FEEDBACK ON PARKING, TC1 CHANGES

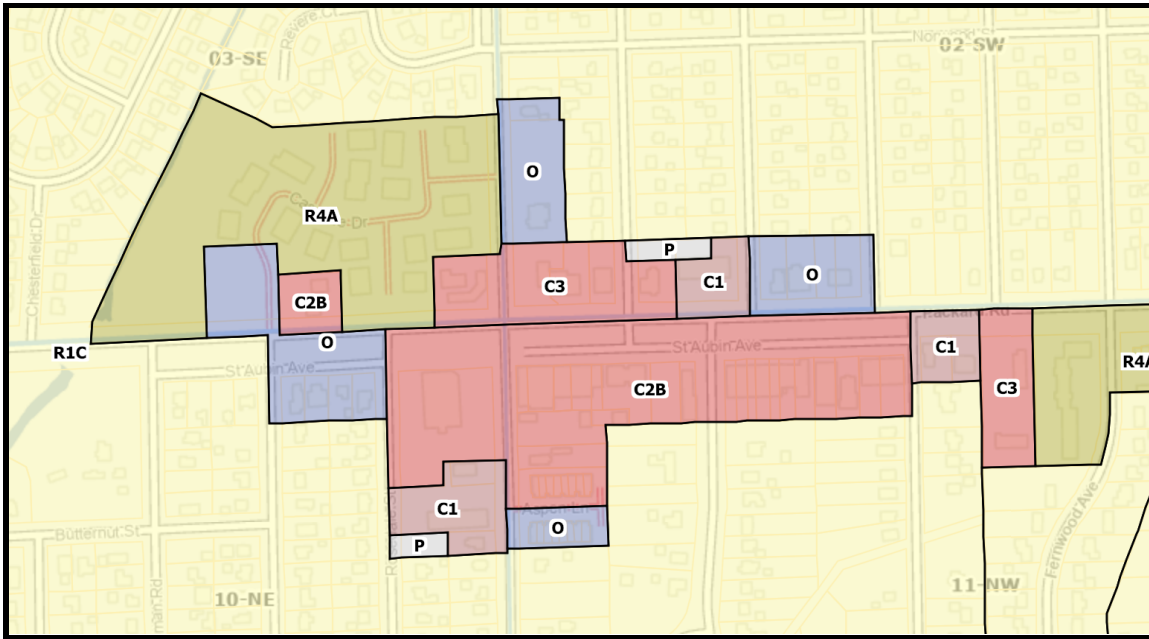
Liberalize the TC1 purpose statement so that: 1) TC1 can replace ANY commercial- or mixed-use parcel, and 2) parcels proposed for rezoning don't need to be "completely surrounded" by commercial districts but rather just "adjacent" to them

1. This district may replace the O, RE, ORL, C2B, C3, P, R5 and M1 districts. It should only replace other zoning designations in unique and rare instances where another zoning district is entirely surrounded by the specifically mentioned districts.
2. This district should be located proximate to a transit corridor, meaning a street with existing fixed transit service. All areas of parcels zoned TC1 should be no more than ½ mile from a transit stop.

TC1 is a flexible district that self-limits building height relative to the proximity of detached residential. In general, I struggle to find a compelling reason why any commercially-zoned parcel shouldn't be eligible for TC1. For example, why shouldn't these C1 properties along Packard be eligible by default? (And, since they're not on the list of eligible districts, they are also disqualified from consideration because they are not "completely surrounded by" the listed types of parcels.)

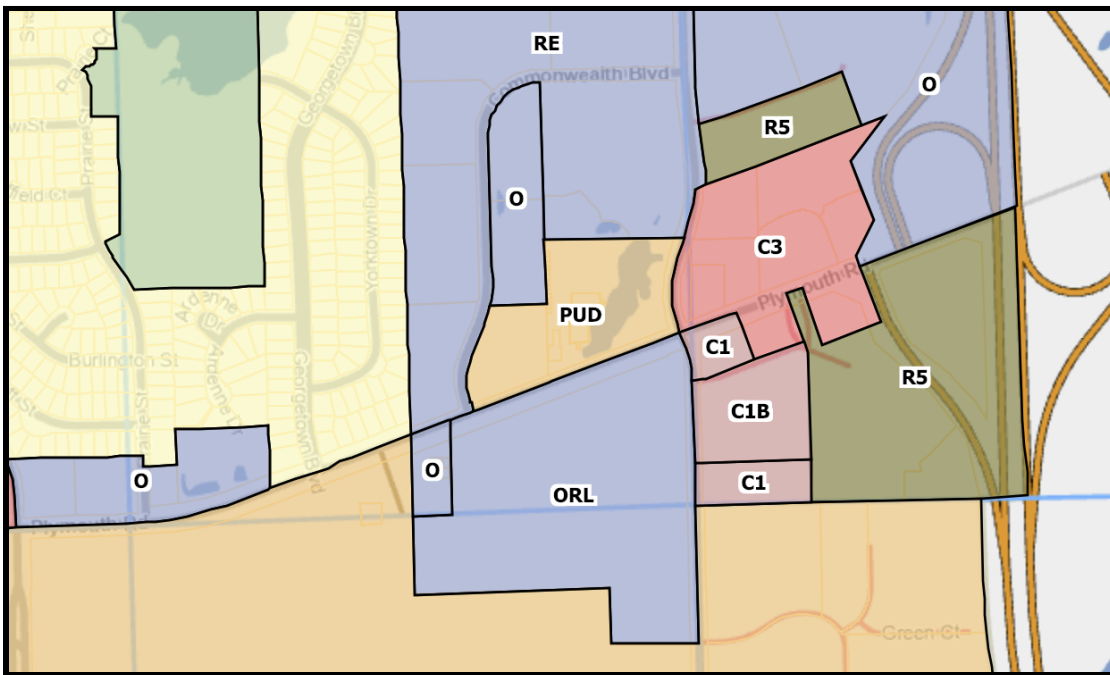
In fact, some of the parcels on corridors that are slated for proactive rezoning (such as Stadium, Plymouth, and Washtenaw) do not even fit this criteria: they are neither in the list of eligible districts (because they are C1 or R4) nor are they “completely surrounded” by the eligible districts (because corridors are typically on the edges of detached-home areas). This fact will be used to fight TC1 rezonings because it’s not following its own rules.
